**BOROUGH OF HIGHLANDS
LAND USE BOARD MEETING**
151 Navesink Ave. - Court Room
Thursday, July 11, 2024 at 7:00 PM

Re: Completeness Review No. 4
Applicant: Kirsh Kraft, LLC
Nine 5th Street
Block 57, Lots 8 & 9
Borough of Highlands, Monmouth County, New Jersey
Our File No.: HLPB2022-04

DATE: 04-05-2024 SCALE: 1"=20' DRAWN: AJC CHECKED: FF SHEET: 5 OF 8 JOB: PR-0290

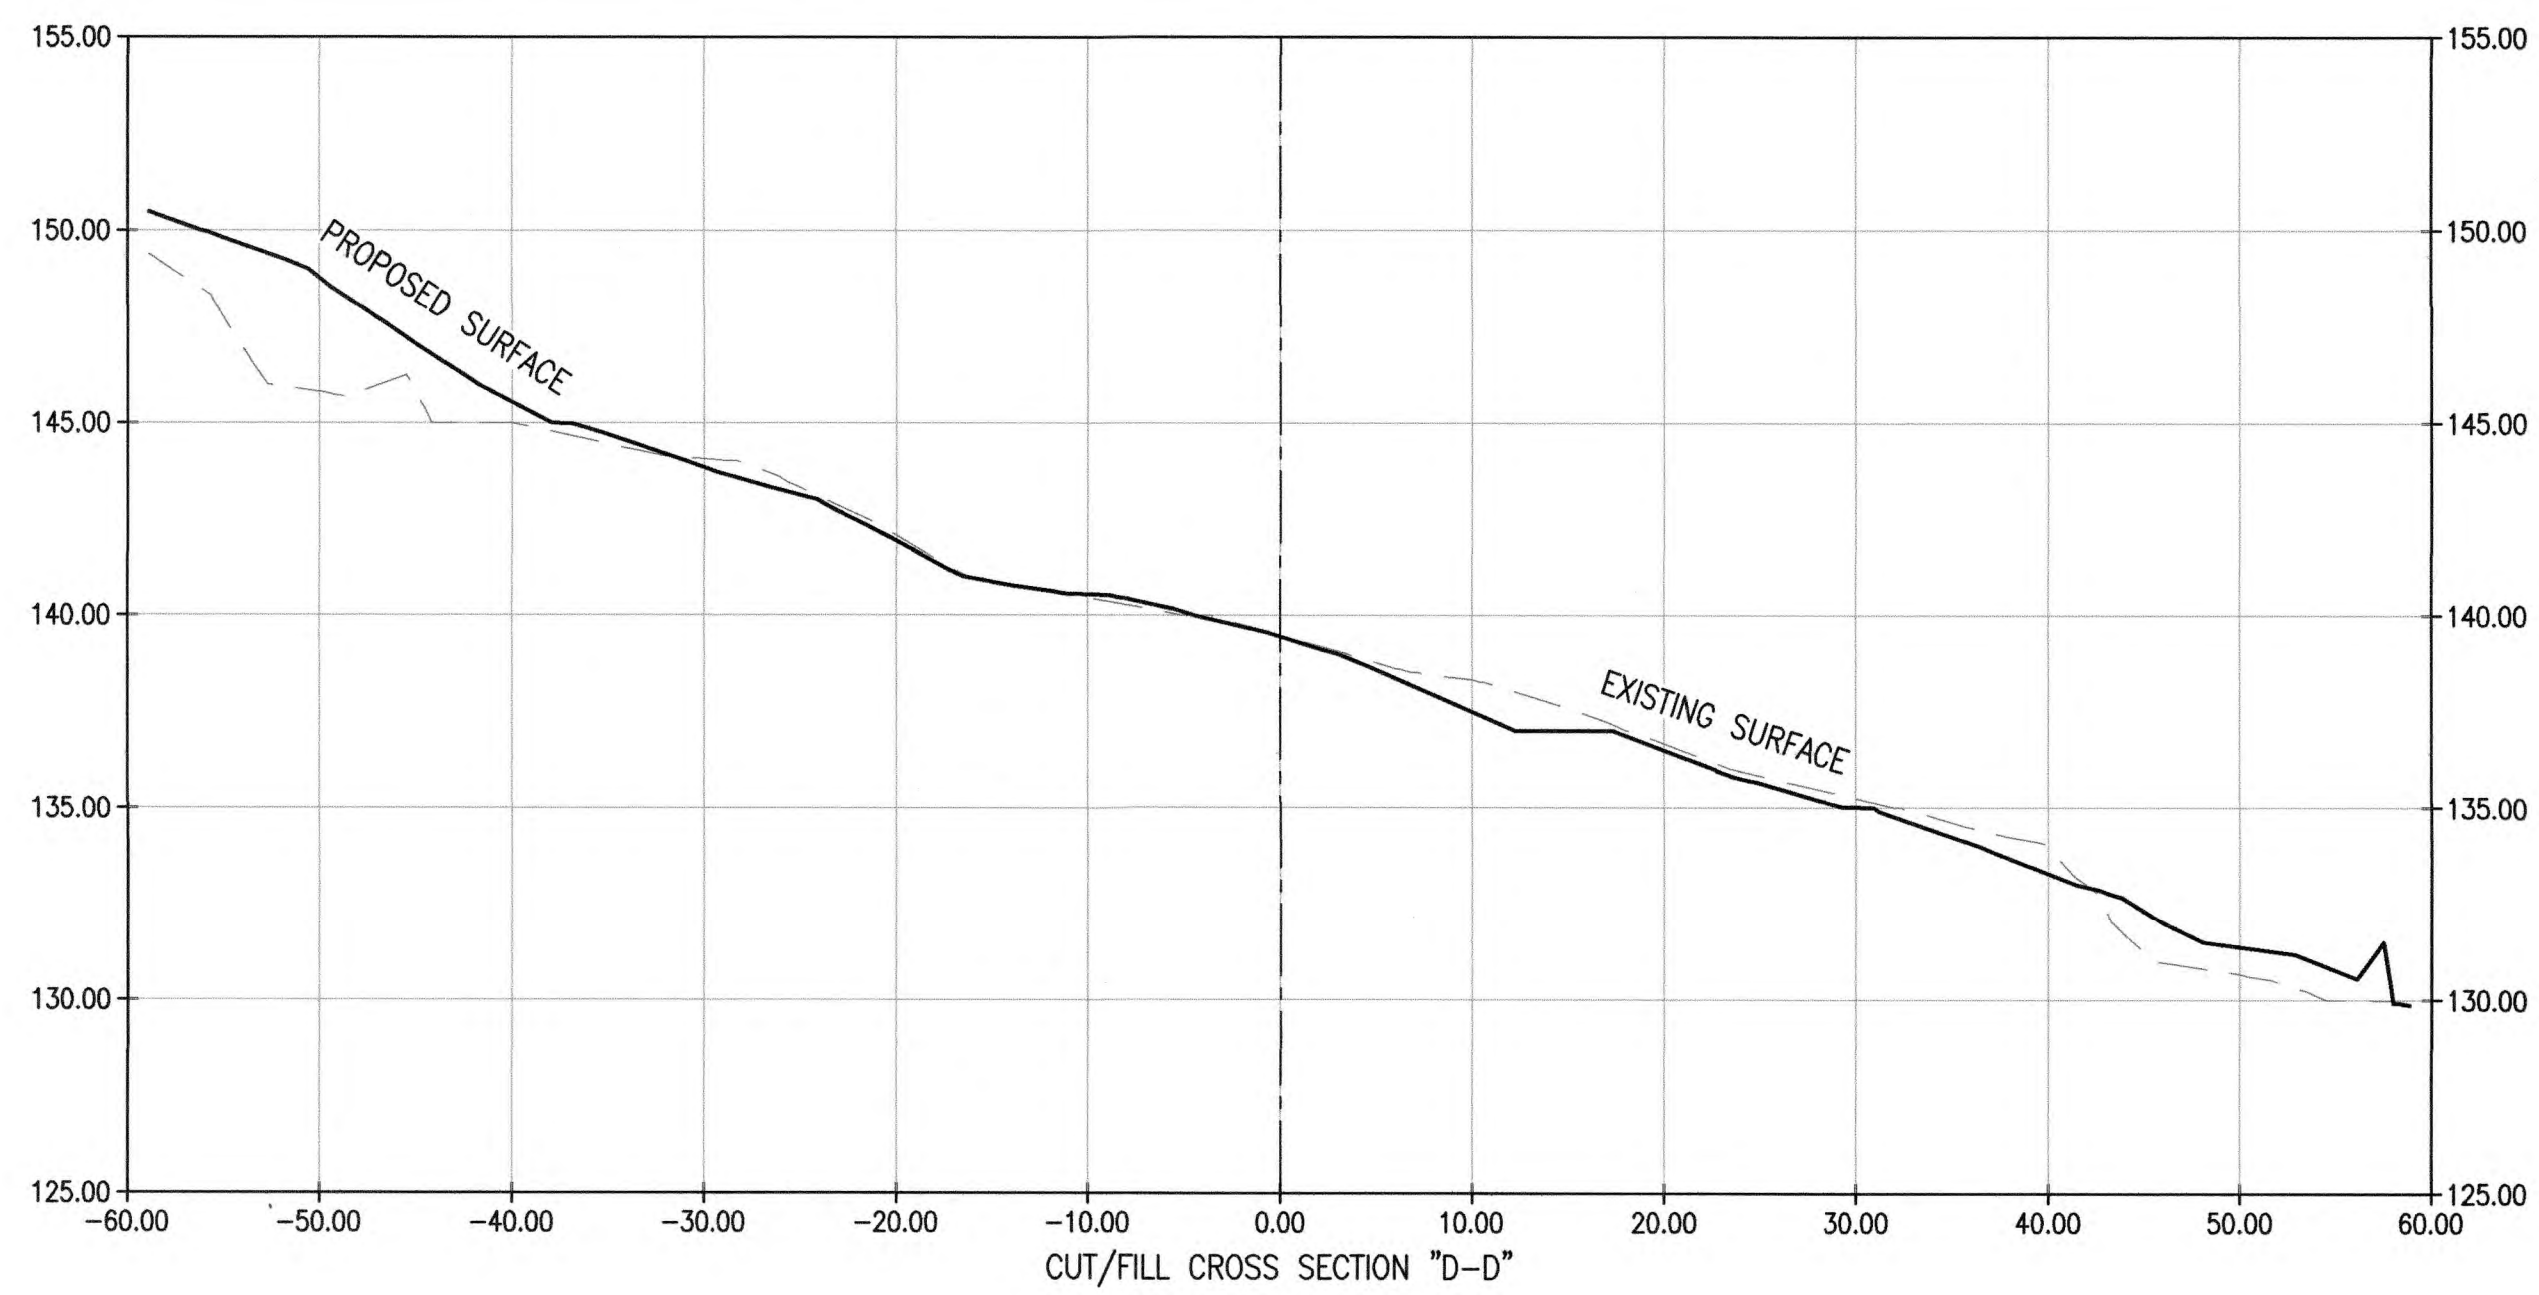
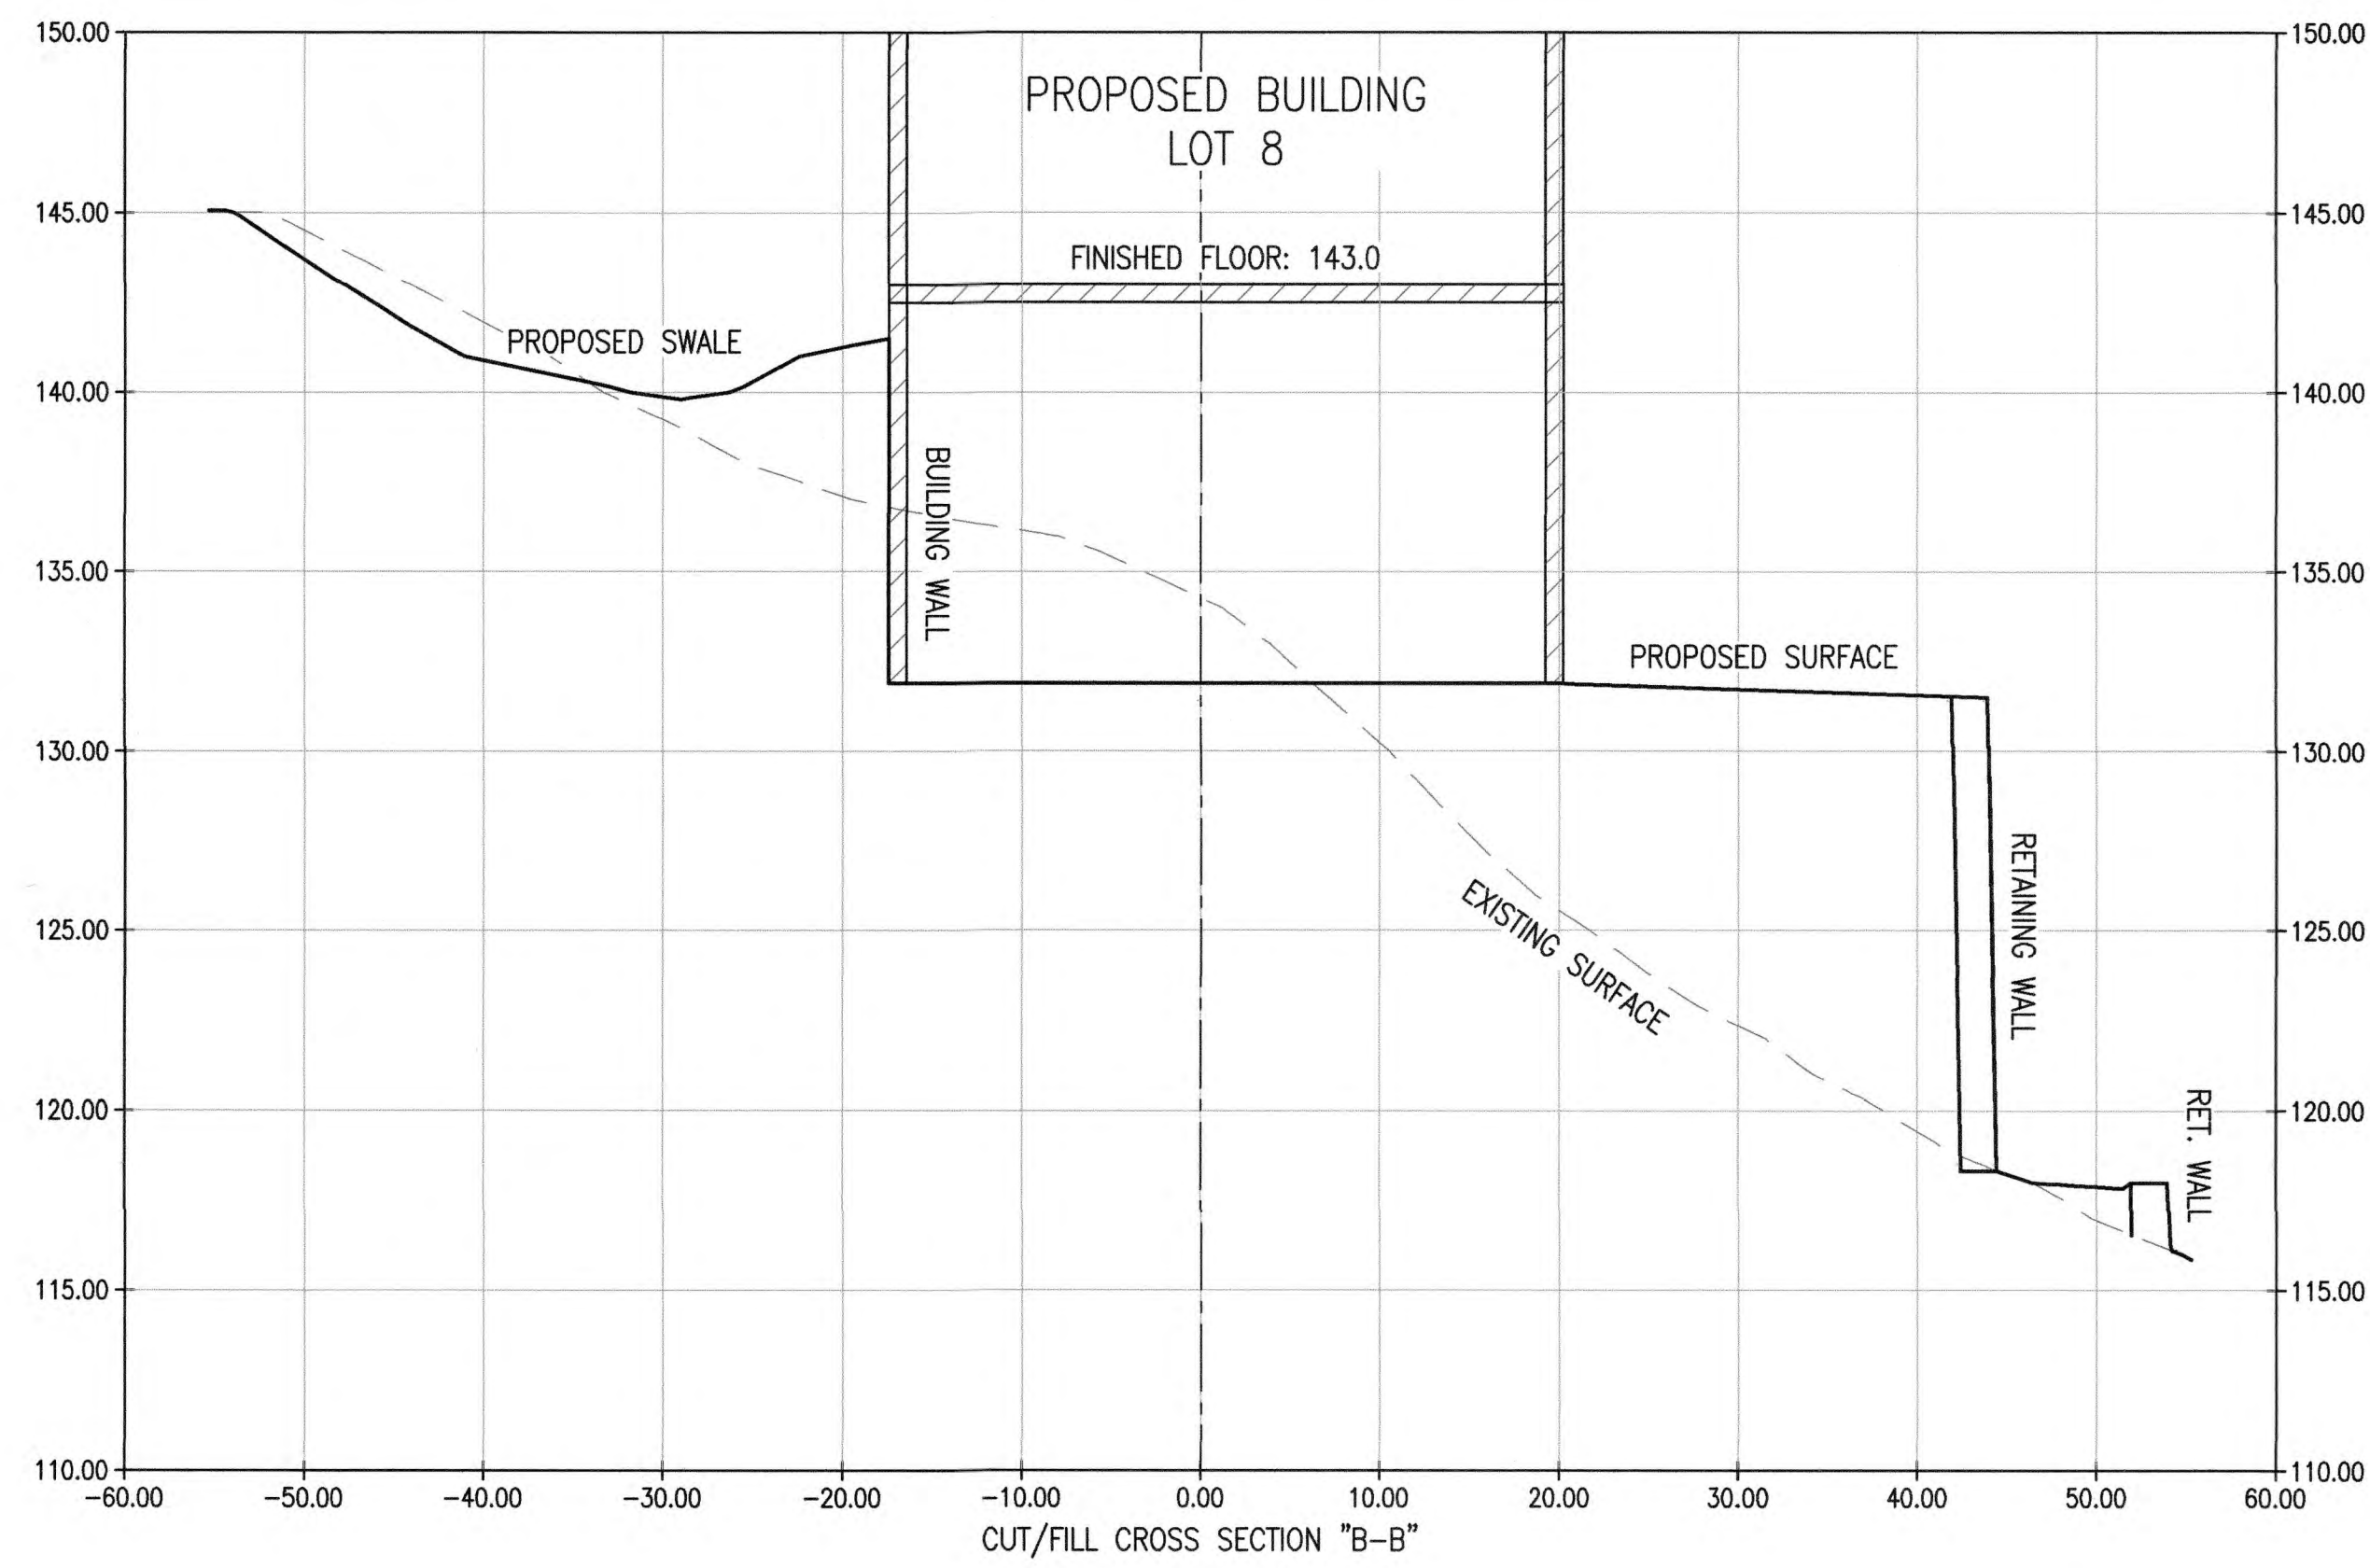
The Applicant is requested to provide a slope area calculation table noting existing and proposed areas of slopes per criteria. The analysis for the Slope Ordinance not only pertains to the subject property but also 100 ft from the boundary of the property. There are slopes greater than 15% as shown on Sheet 2 and the proposed front yard grading on Sheet 3.

This office has prepared a slope analysis plan, see sheet 5 of 8. Additionally, Stormtech (SC-740) Chamber Systems will be installed in the rear yards of each property. The chambers will temporarily store roof runoff during a storm event to control the stormwater runoff. The bottom of the chambers are open and are installed on clean stone which allows the stored water to percolate into the ground. Roof leaders will be hard piped directly to the chambers. Details, size, and specification may be provided upon request.
